HISTORIC AND DESIGN REVIEW COMMISSION

July 15, 2020

HDRC CASE NO: 2020-293
ADDRESS: 237 W HUISACHE AVE
LEGAL DESCRIPTION: NCB 3002 BLK 4 LOT 12 13 AND 14
ZONING: R-4, H
CITY COUNCIL DIST.: 1
DISTRICT: Monte Vista Historic District
APPLICANT: Charles Robinson/ROBINSON CHARLES W III & AMY ABBEY
OWNER: Charles Robinson/ROBINSON CHARLES W III & AMY ABBEY
TYPE OF WORK: Rear accessory structure modifications
APPLICATION RECEIVED: June 23, 2020
60-DAY REVIEW: Not applicable due to City Council Emergency Orders
CASE MANAGER: Rachel Rettaliata
REQUEST:

Proposal

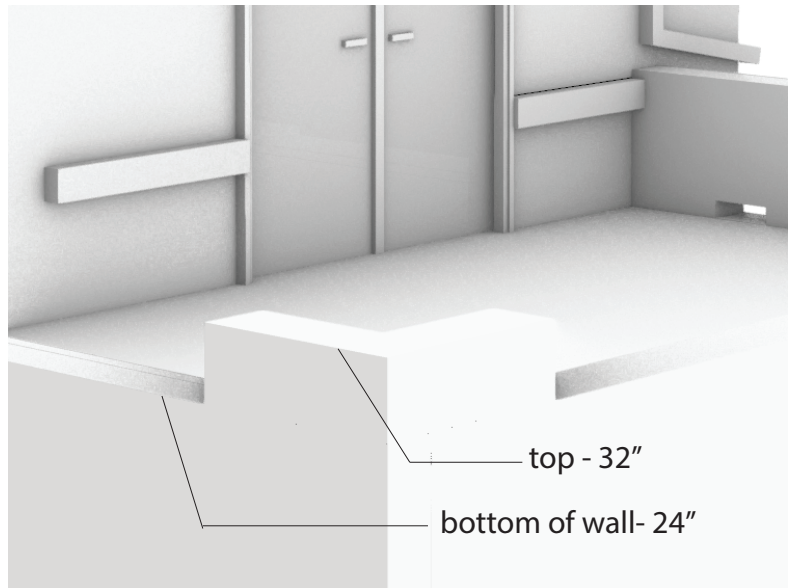
Currently, this roof on our garage is poorly sloped (resulting in pools of water which cause damage). We want to redo the sloping, and we hope to create a nice porch space overlooking the pool in the process.

1. Fix roof Slope / drainage
2. Change the two windows on south face into double doors opening onto porch.
3. Addition of a railing to meet code

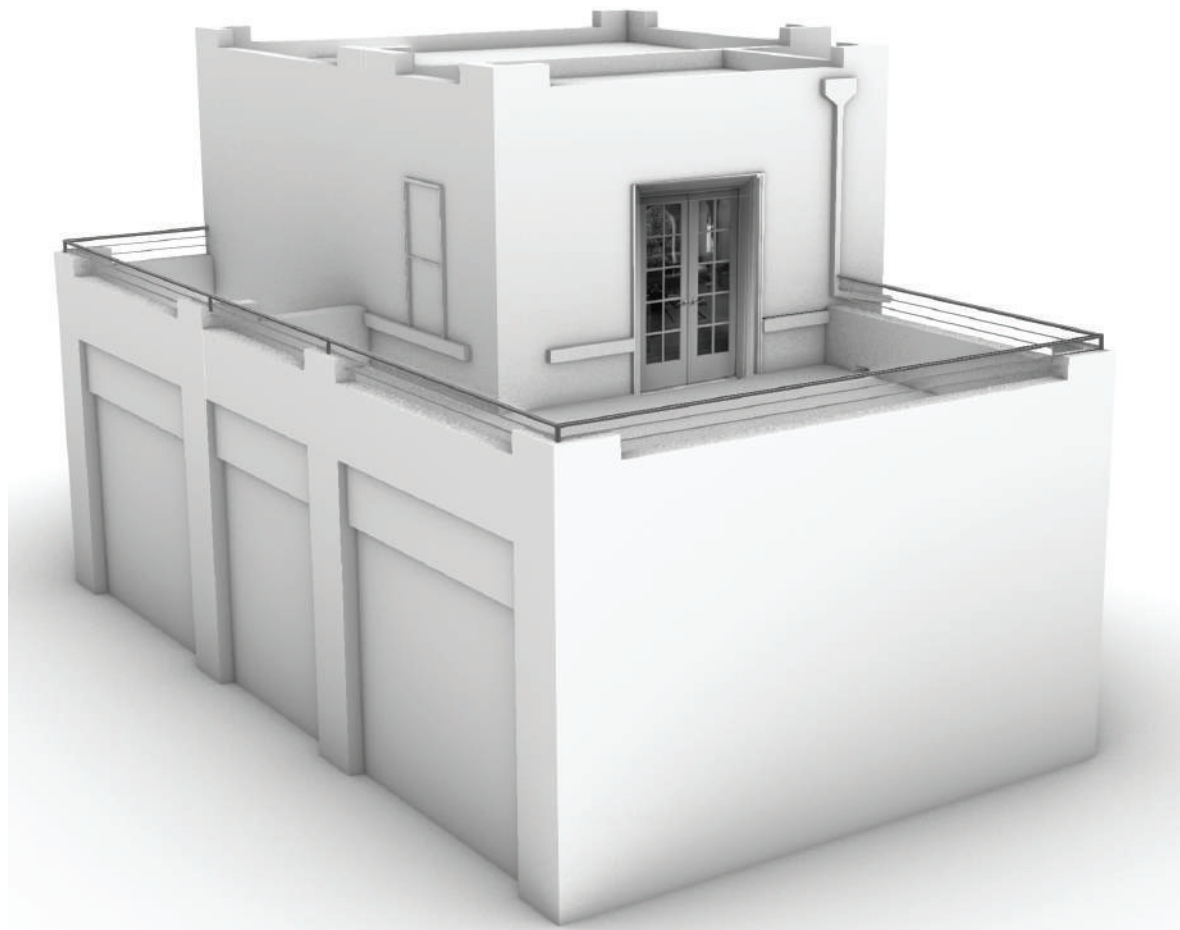
Because the space is now occupiable, plan to add a minimally invasive, simple railing in order to meet 36" height Railing Code:
Minimally invasive, simple iron similar to the time period.
